| | General Arrangement Drawing (2D) (*Tie-In Points , Skid Dimensions & Orientation, Including Instrument, Junction Box and Local Panel Location Layout & Instrument Cable routing.) for Refrigerator Package |   | |
| PO No.: GPIC-PT-MA-PO-000-3029 | Document Number: VD-GPIC-MA-3029-3029-0062 | Rev. 01 | Page 1 of 10 |

|  Energy Industries Engineering & Design co. | Date: Oct.04, 2025 |

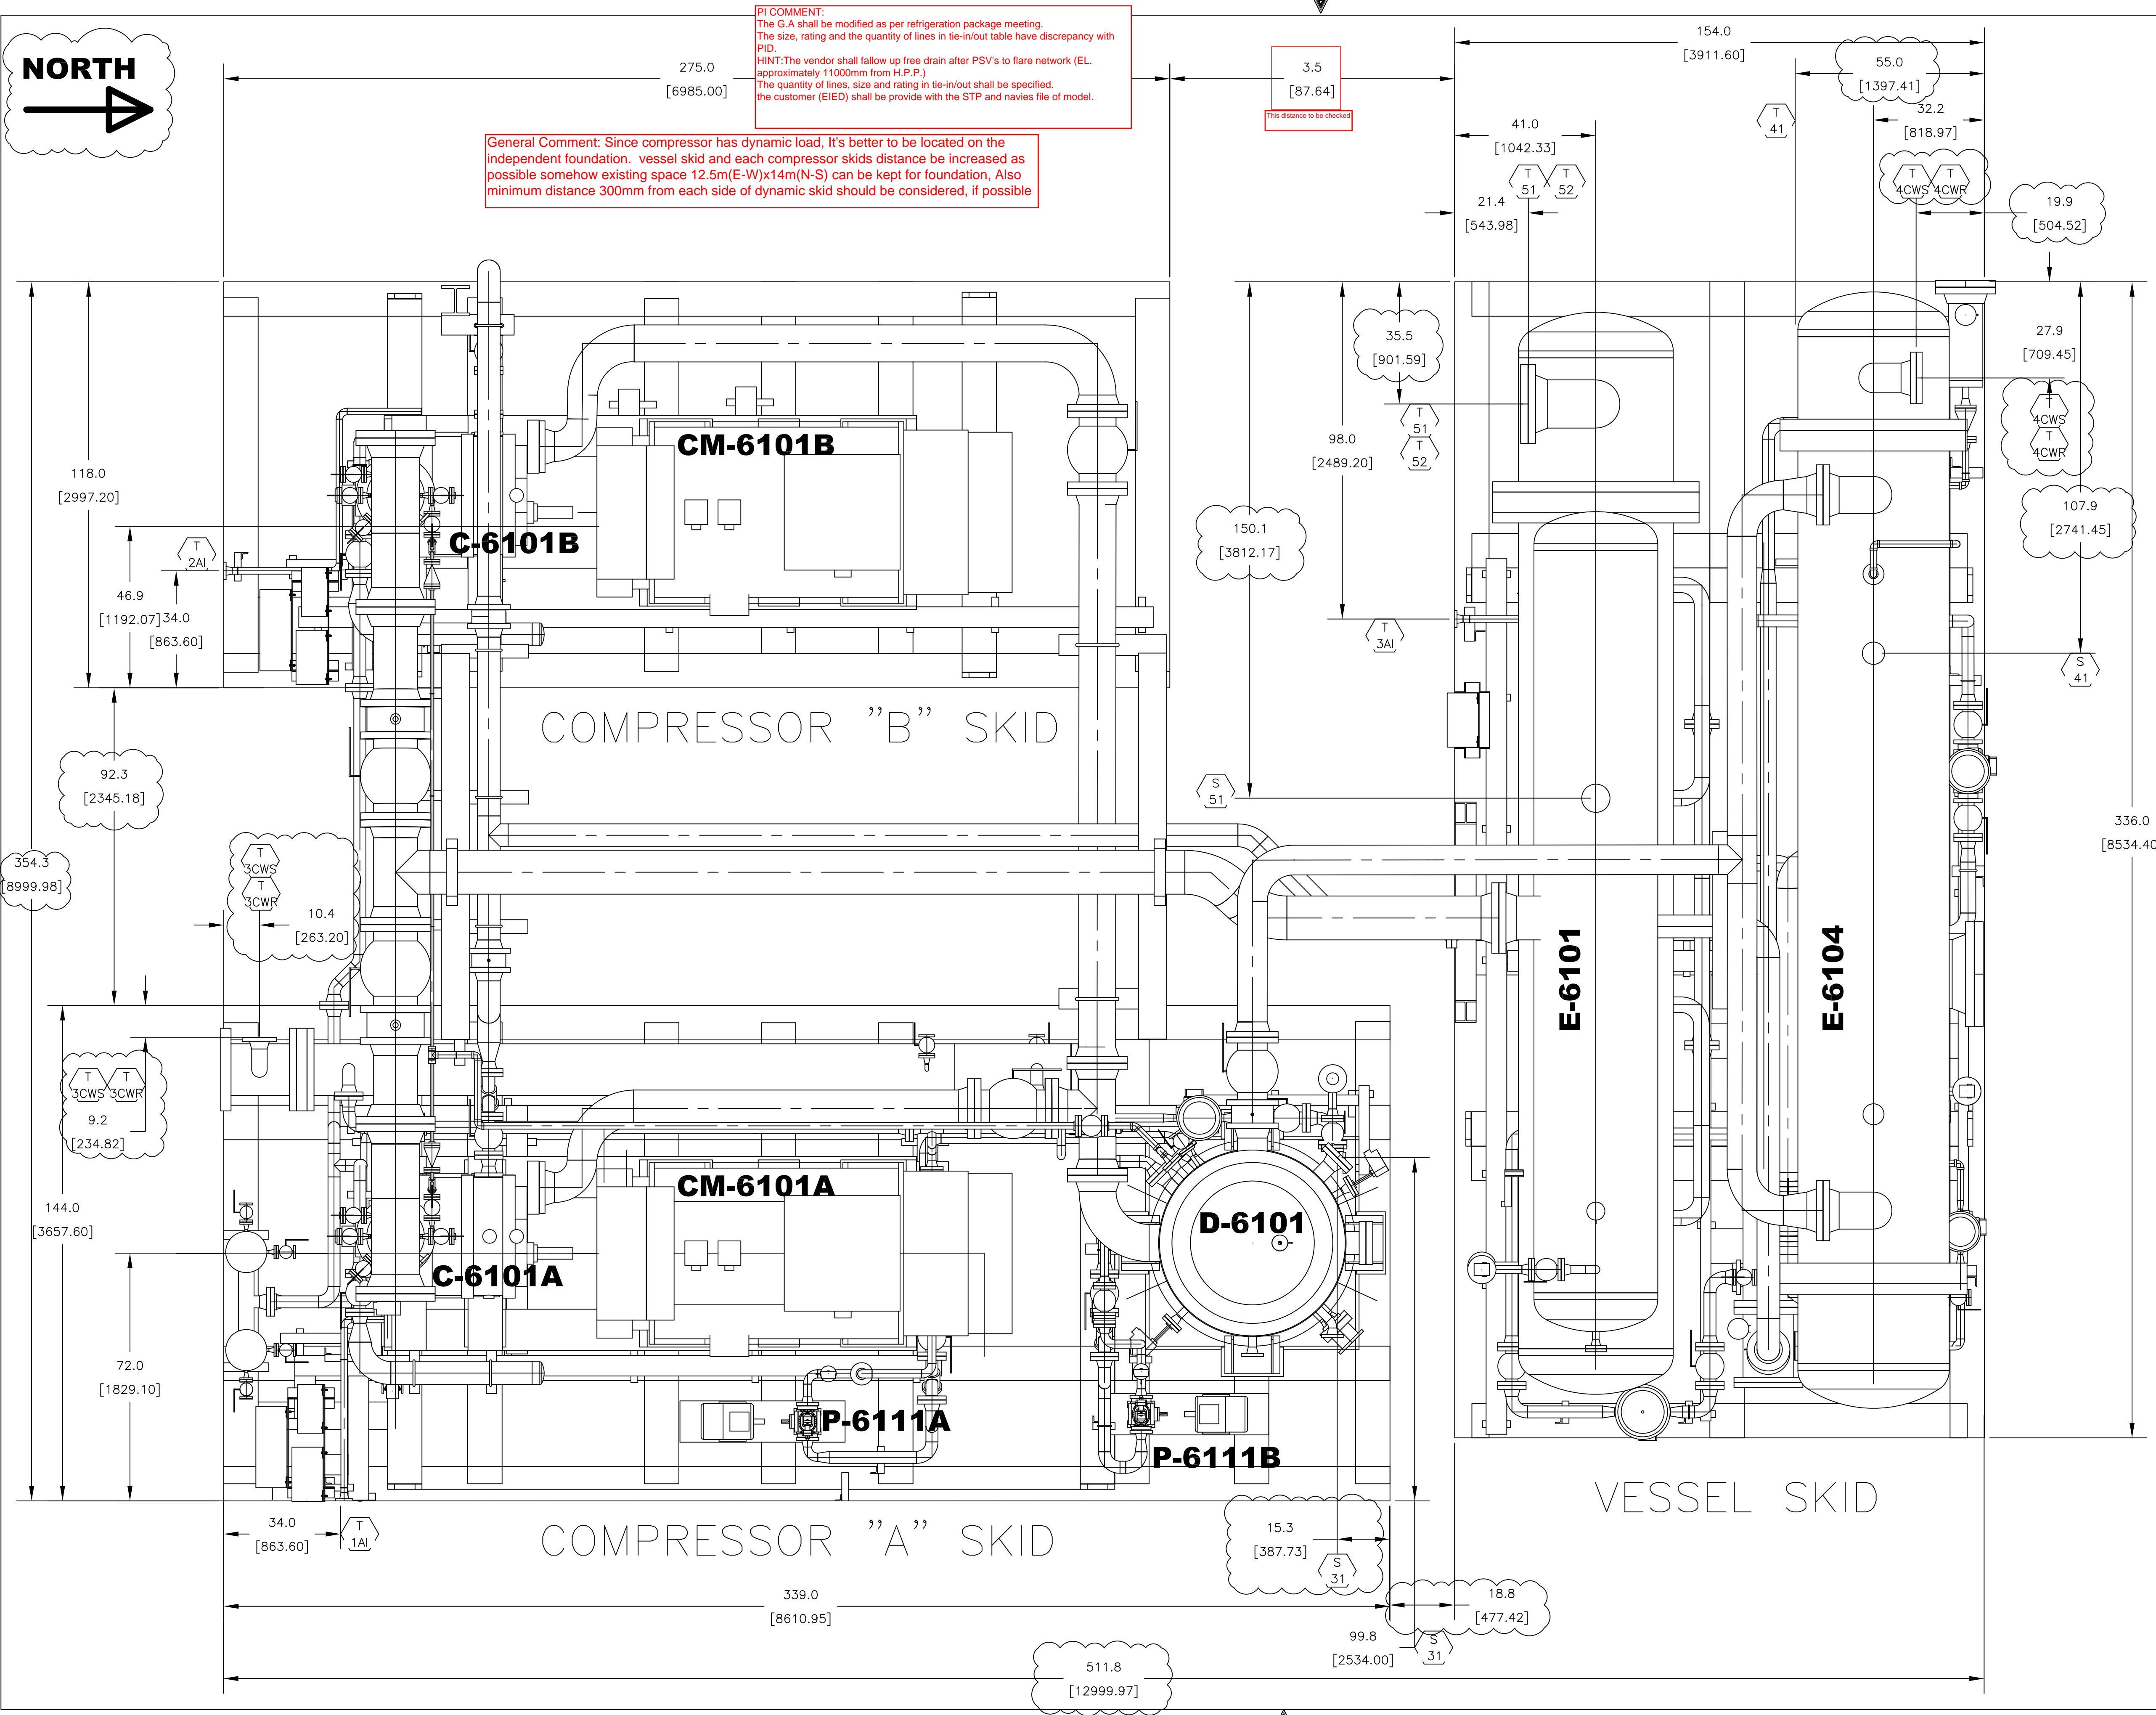
PI COMMENT:
 The G.A shall be modified as per refrigeration package meeting.
 The size, rating and the quantity of lines in tie-in/out table have discrepancy with PID.
HINT: The vendor shall follow up free drain after PSV's to flare network (EL. approximately 1100mm from H.P.P.)
 The quantity of lines, size and rating in tie-in/out shall be specified.
 The customer (EIED) shall provide with the STP and navies file of model.

General Comment: Since compressor has dynamic load, It's better to be located on the independent foundation. vessel skid and each compressor skids distance be increased as possible somehow existing space 12.5m(E-W)x14m(N-S) can be kept for foundation, Also minimum distance 300mm from each side of dynamic skid should be considered, if possible

FRONT VIEW

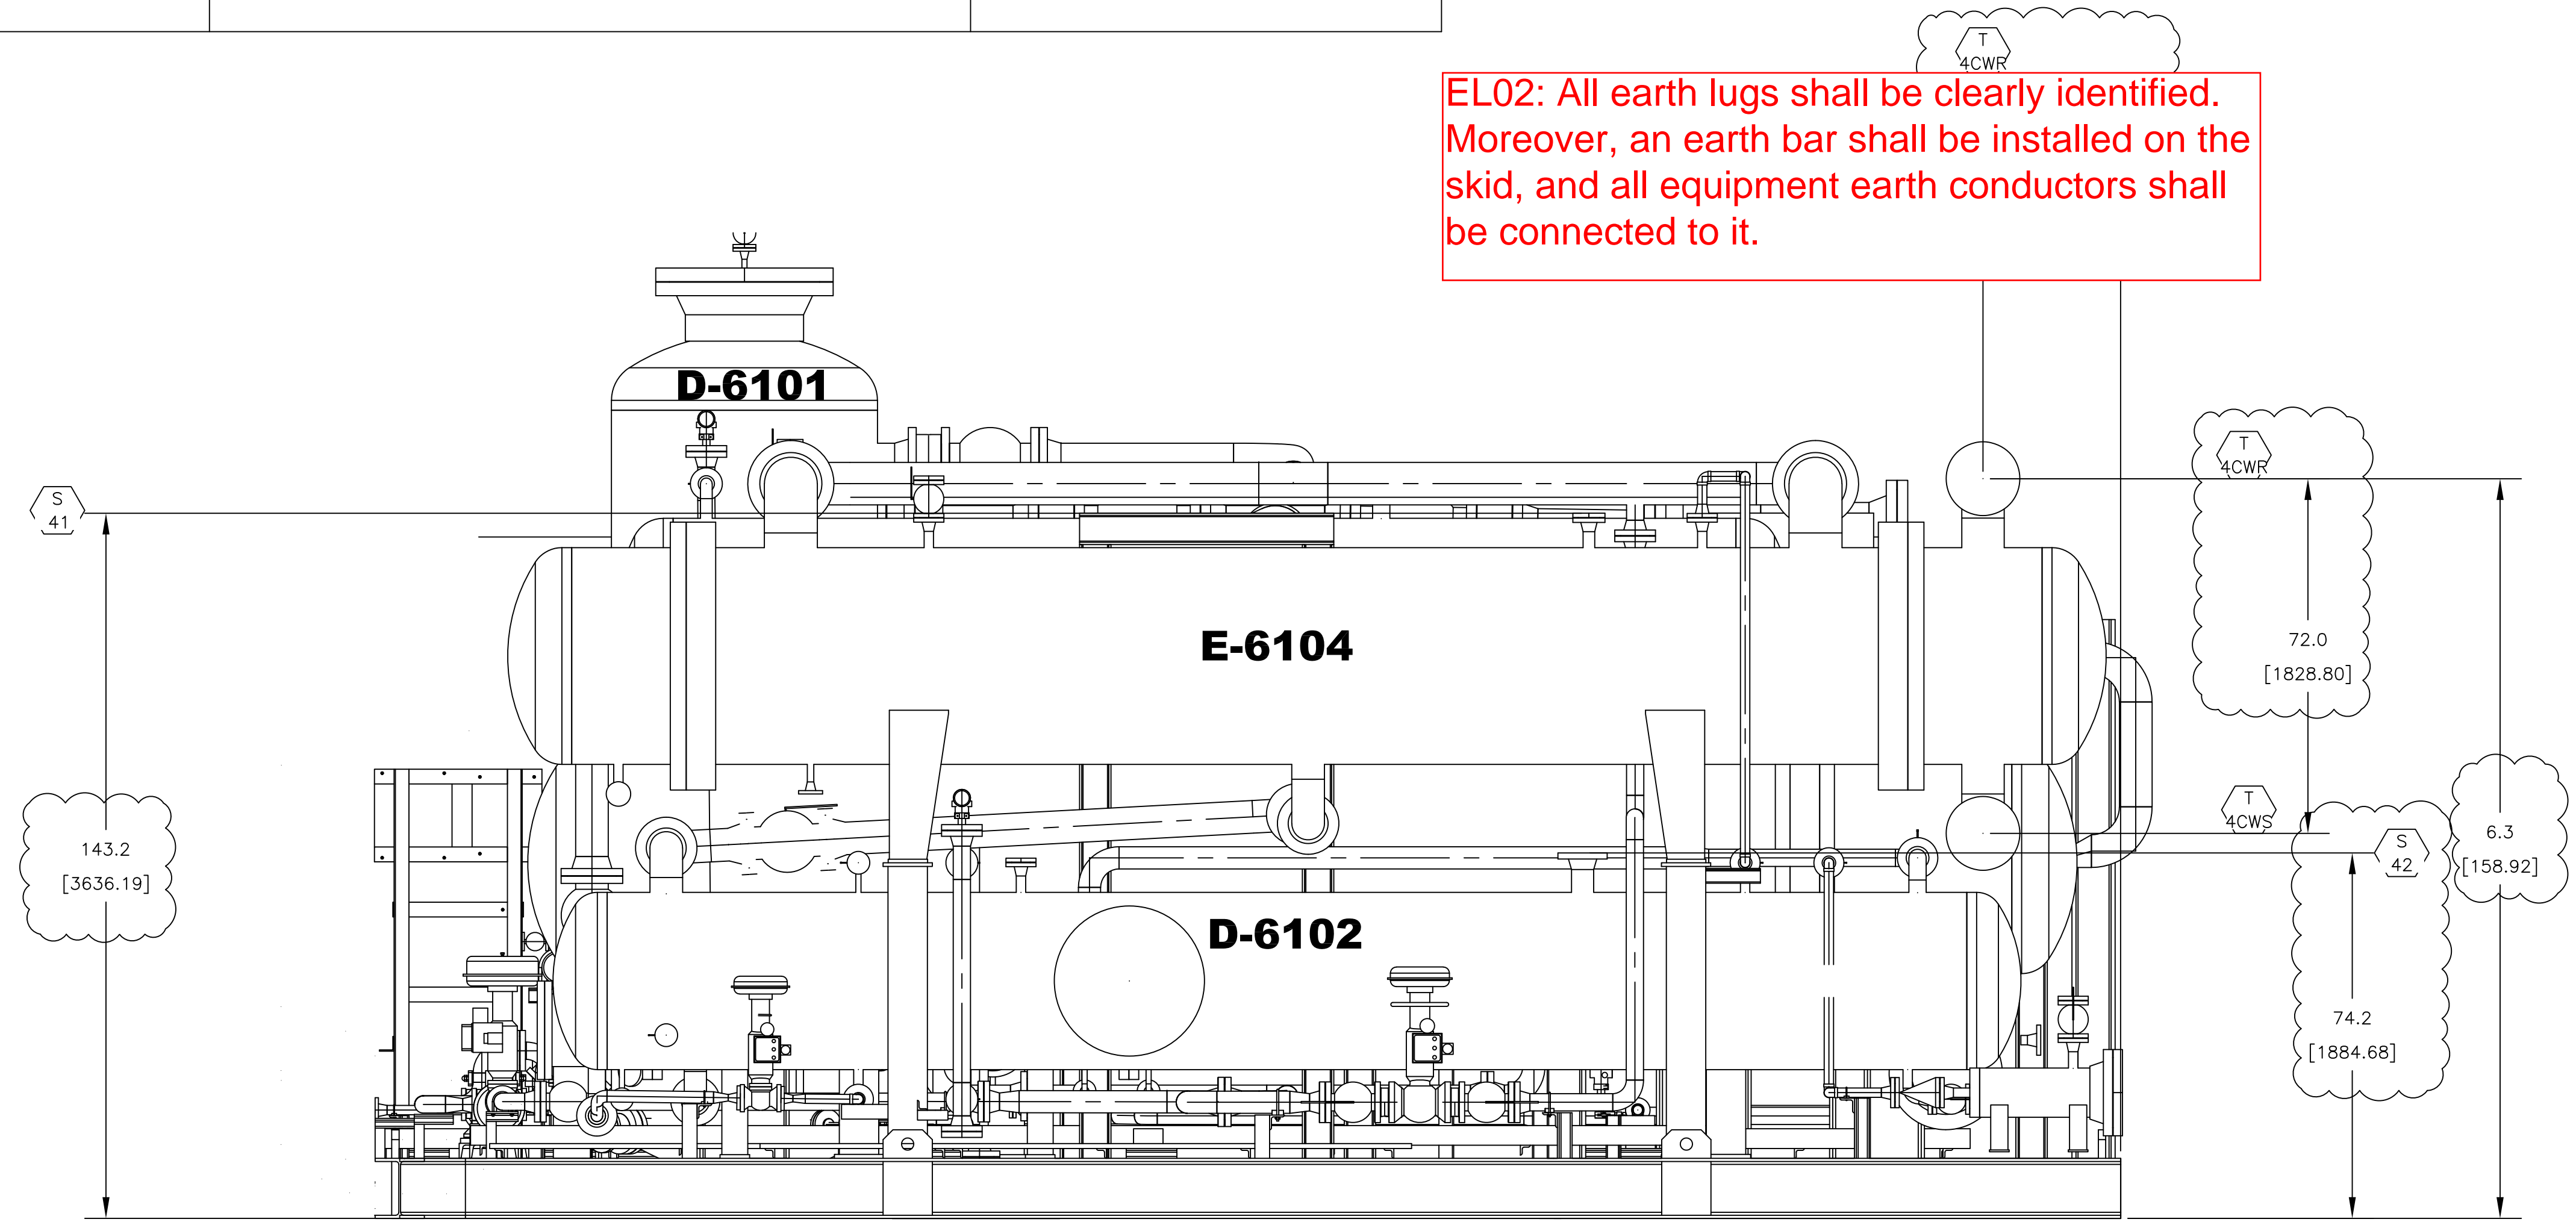
EL01: Local Panel and junction boxes shall be numbered and displayed in a table with tags.

Vendor Shall confirm:
Gasket contact surface finish for raised or flat faces Flanges, Blind Flanges, Spades, and Spectacle Blinds, shall be finished in accordance with ASME B16.5, concentric or spiral serrated (125-250 µin. AARH) and for RJ flanges as per 63 µin. AARH.

EL02: All earth lugs shall be clearly identified. Moreover, an earth bar shall be installed on the skid, and all equipment earth conductors shall be connected to it.
